Docket Number:	22-BSTD-01
Project Title:	2025 Energy Code Pre-Rulemaking
TN #:	252178
Document Title:	Daikin US Corporation - Dave Calabrese Comments
Description:	N/A
Filer:	System
Organization:	Daikin US Corporation - Dave Calabrese
Submitter Role:	Public
Submission Date:	9/7/2023 3:40:14 PM
Docketed Date:	9/7/2023

Daikin Comment Letter

Re: Docket 22-BSTD-01

II. Applying EER2 thresholds for PV System Sizing could be counterproductive for adoption of variable speed heat pumps

Figure 1: PV Sizing requirements for Heat Pumps under 11.7 EER2 in CEC’s 2025 Energy Code Pre-Rulemaking Docketed Document

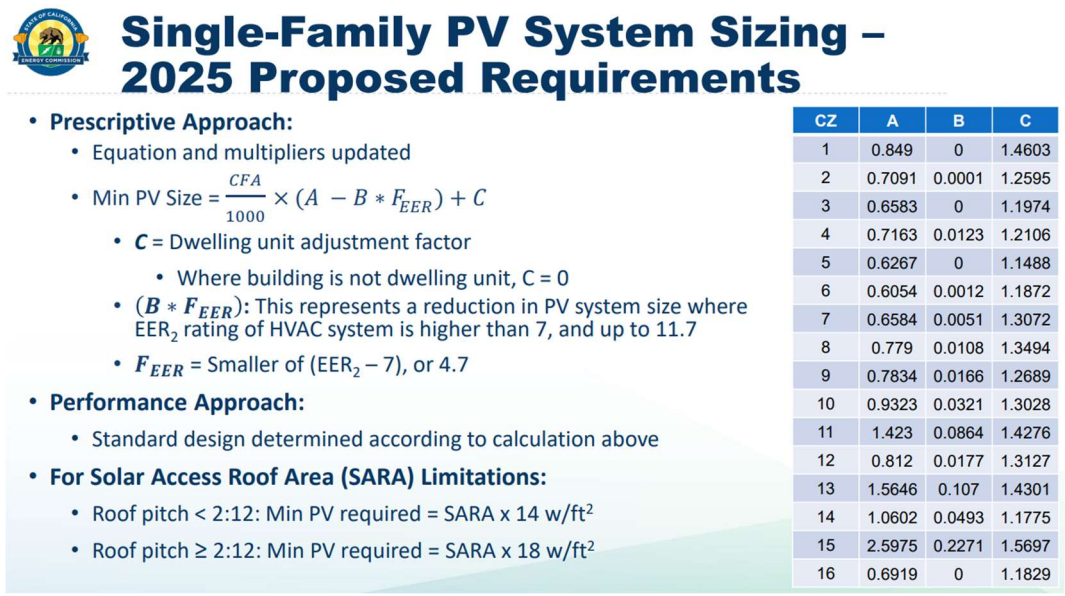
Daikin supports the Energy Code and the benefits of replacing gas fired equipment with electric alternatives, in addition to PV Systems. Daikin understands that this PV system sizing 2025 proposed requirements is intended to address that lower EER2 HVAC systems could increase peak power usage and thus requires larger PV systems. Yet Daikin believes that, while EER2 can be effective to manage peak demand for fixed-speed HVAC systems, as mentioned in the rest of this section, the metric is an irrelevant to do the same for VSHP technology. In consequence, we believe that prescribing EER2 for sizing PV Systems, as currently proposed, could be counterproductive to the adoption of VSHP technology and the attainment of the state’s heat pump and decarbonization targets per Figure 1 below. Therefore, Daikin proposes that F_{EER} should be fixed at 4.7 for the VSHP technology.

EER2 is not a metric that in any way captures the benefits and performance of VSHP’s. As explained below, Daikin believes that requiring EER2 for VSHP PV System integration may slow their adoption and fail to recognize and capitalize their inherent benefits.

Daikin urges the CEC to revise the specification requirements in the proposed 2025 Energy Code Pre-Rulemaking such that EER2 is not a metric used for sizing PV systems for VSHP's. Daikin also urges the CEC to utilize the DOE published paper data, Residential HVAC Installation Practices, 2018, for cooling dominated climate zone design key assumptions to accurately reflect the current HVAC installed residential systems in the field, which are currently oversized, on average, by 40%.

Figure 2. Applied EER2 calculations for a typical equipment operation at below full load conditions.

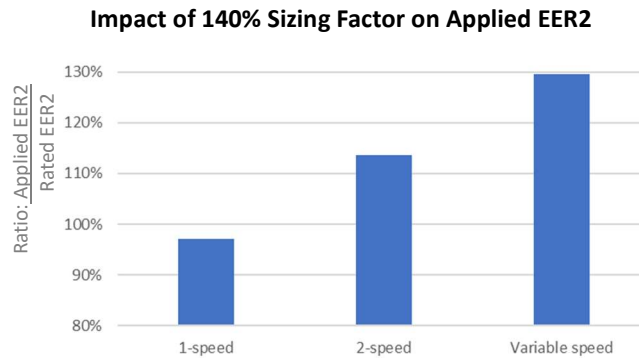
The EER2 metric is intended to measure peak load performance at 95F outdoor. This test condition, per DOE Appendix M1, has 100% sizing factor, meaning the system is tested at full capacity at 95F. When a VSHP operates in an unloaded state, as is does when applied with over 100% sizing, the operational efficiency increases. This improved applied efficiency is not accounted for in the DOE Appendix M1. However, DOE uses a 110% sizing factor for typical in SEER2 calculations. A similar

sizing consideration is not reflected in the EER2 metric. Consequently, unit efficiency is impacted due to unmatched load and capacity when sized with this factor. Furthermore, similar sizing of fixed speed heat pump systems will lead to cyclic operation and resultant loss of efficiency, whereas VSHP systems can operate in partial load operation modes at higher efficiency.

While 110% sizing is used in the SEER2 calculations, real-world equipment sizing is even larger. DOE published a paper³ that found that typical equipment sizing in real-world applications ranges between 133-148%. Daikin conducted an analysis using DOE Appendix M1 calculation method to evaluate the impact of this real-world sizing practice compared to the EER2 rated condition. With a typical 140% sizing based per DOE’s paper, the evaluation showed that the applied EER2 of a single speed unit can drop to 97% due to cyclic operation, whereas the applied EER2 of VSHP systems may increase up to 130% due to partial load operation (see Figure 1). This result demonstrates that EER2 does not represent true peak load energy efficiency in actual field conditions, particularly for VSHP systems and the industry sizing practices discovered by the DOE.

Figure 3. Percentage of hours for high ambient conditions for 12 cities, 2019-2021

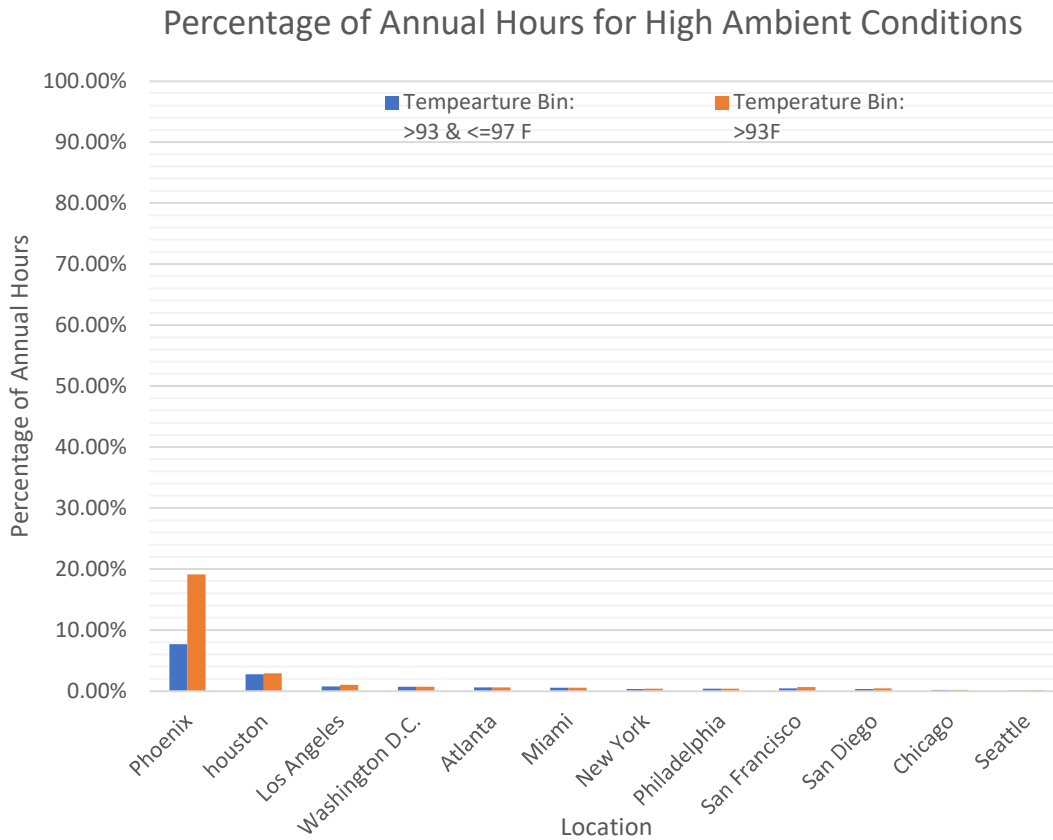
As shown above, EER2 is a metric measured at high ambient (95F) conditions. High ambient conditions, however, represent only a small portion of time in a year across most locations in the US, albeit an important time period from a load management perspective. Figure 2 shows percentage of bin hour of high ambient condition (>93F) at a few densely populated US cities. Based on weather data from National Oceanographic and Atmospheric Agency (NOAA) for twelve major U.S. cities (Phoenix, Houston, Los Angeles, Washington D.C., Atlanta, Miami, New York, Philadelphia, San Francisco, San Diego, Chicago and Seattle), the average duration that the temperature exceeded full load temperature conditions (>93F), between 2019-2021, was only 2.2% of the total annual hours. The average duration that cities experienced temperature conditions between 93-97F was 1.2% of the annual hours.

Specifically, in California, across its 16 climate zones, based on weather data from 2017, the average number of hours over 95F is estimated to be 189 hours annually, which is about 4.4% of total cooling load hours. Some of the hotter CA climate zones experience over 30% of cooling operating hours above 90F with over 20% of cooling operating hours above 95F as well. However,

we note that in the study published by the DOE⁴ that most of the products installed in homes are oversized. As a result, it is expected that due to potential oversizing of HPs sold in California, they can adequately meet the cooling and heating loads, provide options for load shedding and provide higher efficiency operation for the majority of its annual operation.

Figure 4. Charge size relationship with EER2 and SEER2 for 2-Ton Heat Pump systems

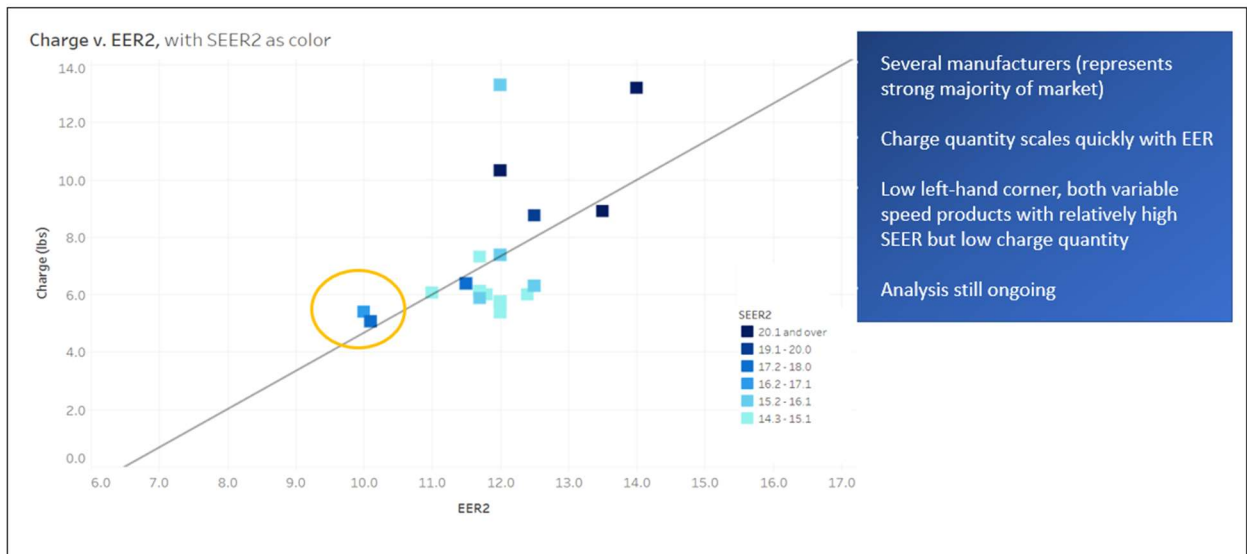
Based on our analysis of the charge sizes for models with varied EER2 and SEER2 ratings, we can observe that the charge size tends to increase with increasing EER2 levels (see Figure 3). This is expected because a bigger heat exchanger enables heat exchange with lower power consumption, because it leads to a lower pressure difference between the OD and ID units. While this drives up the EER2 ratings, it also requires more material and larger refrigerant charge sizes. Larger refrigerant charge sizes are required to accommodate the longer channel length of heat exchangers. This raises concerns because there will be limitations to the total amount of refrigerant available in the market, as a result of AIM Act allocations. Creating a policy that indirectly encourages the use of equipment with larger charge sizes is also directly in conflict with the fundamental premise of new federal regulations that phase down the use of high Global Warming Potential (GWP) refrigerants (i.e., the AIM Act). With limited refrigerant allocations, CEC should consider deployment of technologies that reduces charge sizes while still meeting the heating and cooling loads for the majority of the year.
